2013 Surface Mining Inspection Report
Robertson's Ready Mix
Banning Quarry
CA Mine ID# 91-33-0012

December 30, 2013
Project No. 4212-MI

Subject: 2013 Surface Mining Inspection Report
Robertson's Ready Mix "Banning Quarry"
CA Mine ID# 91-33-0012
City of Banning, Riverside County, California.

Figure No. 3, Flood Zone Map

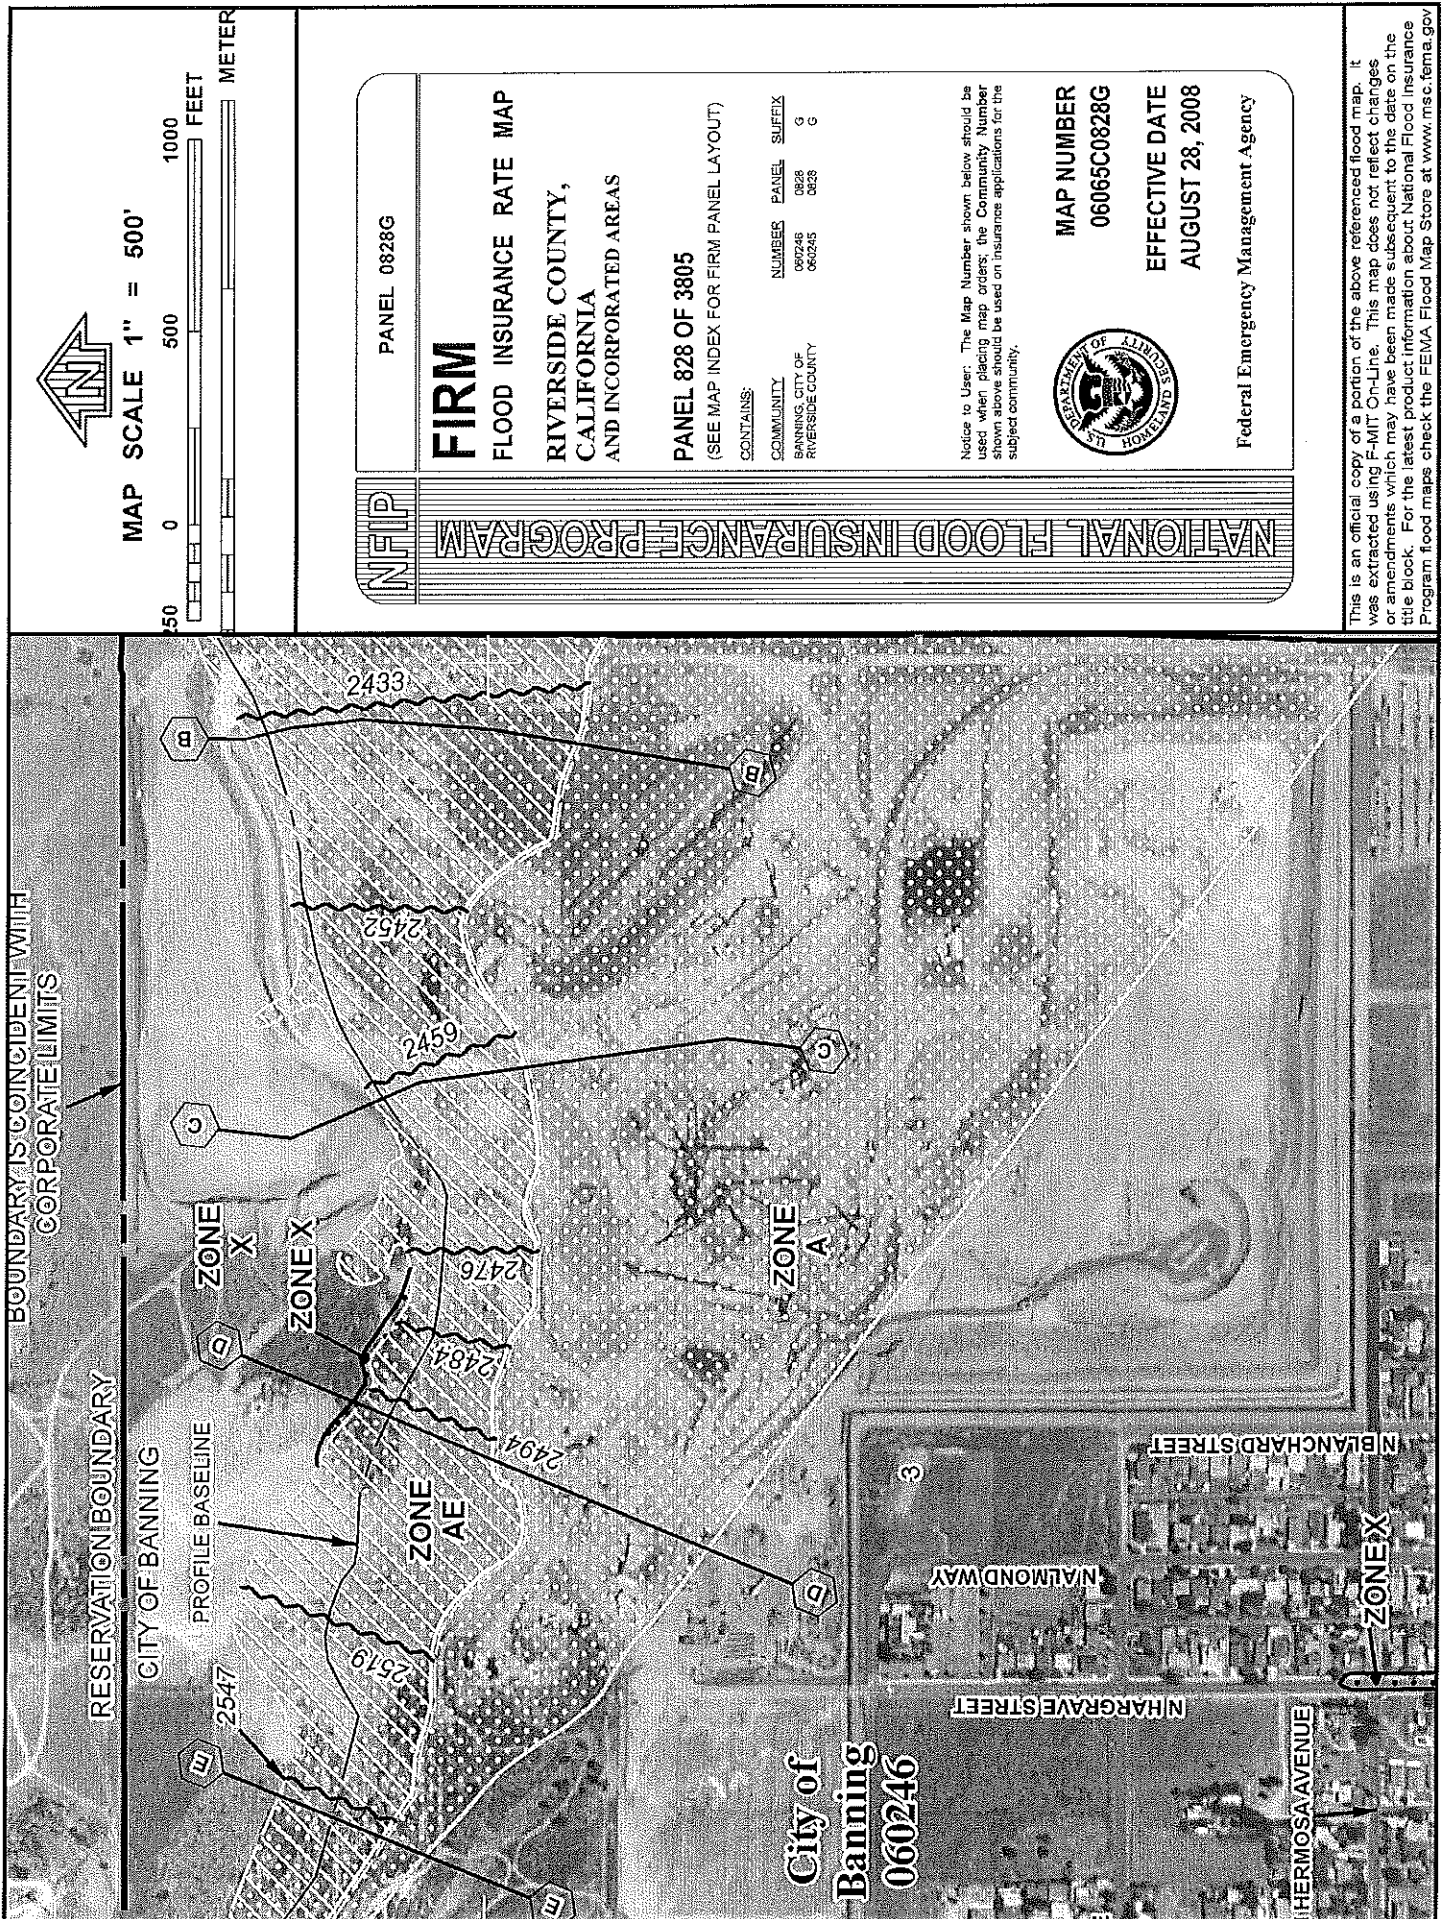
flood zone "A" per the governing flood insurance rate map (FIRM, Figure 3 on the next page). The FIRM clearly relies on data predating the establishment of Banning Quarry pits and has essentially zero relationship to present site elevations. Nonetheless, the map remains in force per Banning municipal codes and ordinances unless the zone is modified.

The greatest uncertainty currently lies with the design and condition of the right-bank dike along the San Gorgonio River. The City of Banning does not have reports indicating the dike is an engineered feature with controlled compacted fill. The crest width is locally less than specified in the (old) vested-mine reclamation plan, and mostly lacks erosion protection on its stream side. Failure or overtopping of this feature would potentially flood the West or East pits (and/or future resource excavations after processing plant relocation). Avulsion would be accompanied by upstream knickpoint migration and renewed headcutting in the streambed. It is not known whether this could create risk to the Banning Levee.

Zone modification would be by petition for a "Letter of Map Revision" (LOMR) filed with FEMA. We speculate that the LOMR would at a minimum require enhancement or reconstruction of the right-bank San Gorgonio levee. Supporting hydraulic calculations for equilibrium bed elevations would be needed. Summarizing:

FIGURE C-1

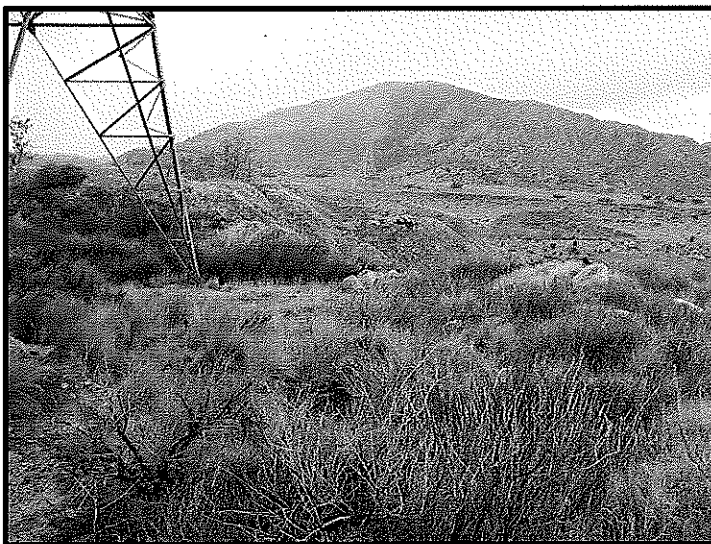
Photo 3: Devers-Vista #1 and #2 tower leg, adjacent to East Pit. Distance from the tower leg to the brow of a 100-foot-high descending cut slope (out of view) was measured at 17 feet. Foreground vegetation could be representative of “natural” conditions, as the tower footprint is one of the very few and very small areas of undisturbed ground.

FIGURE C-2

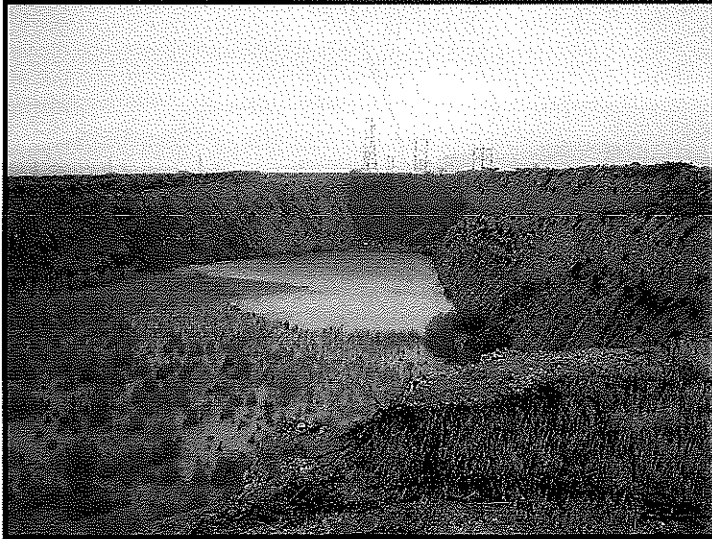
Photo 4: East Pit, view south from SCE easement. The eastern pit wall (left side) features loose soil slopes at natural angles of repose with some steeper projections of intact alluvial strata. The eastern slope approaches, but does not appear to cross, the property boundary with the adjacent Morongo Indian Reservation. This pit has been used for years as the disposal site for washed fines generated from the sand and gravel processing plant. Interpretations of CUP 1965 reclamation plans and the latest-available contour maps indicate that at least 17 feet of sediment is beneath the pond, thickening to the north. The ¾:1 cut slope in the right half of the picture has stood for at least 30 years. It has experienced some deep rilling and exhibits relatively sparse vegetation. It is believed this slope will be mined to pond elevation. Pondered water evaporates, or infiltrates into the excavation sidewalls.

Photo 5: South Pit, view north. The northern pit wall has undergone slope trimming with a dozer and slope board, to create a benched surface with benches estimated at 20-foot intervals. The South Pit has been the primary aggregate source for the last year.

Photo 6: West Pit, view east along the northern highwall to show start of natural vegetation restoration. Noted that benches are becoming indistinct under a surficial cover of loose talus. Dense tamarisk is present where perennially saturated ground has been experienced due to spring flows (lower right). Pit bottom shows evidence for some extraction. Future resources continue east, under the existing plant site. The operator affirmed that relocation of the processing plant to the bottom of the South Pit is planned and will be documented in a new site-wide Reclamation Plan.
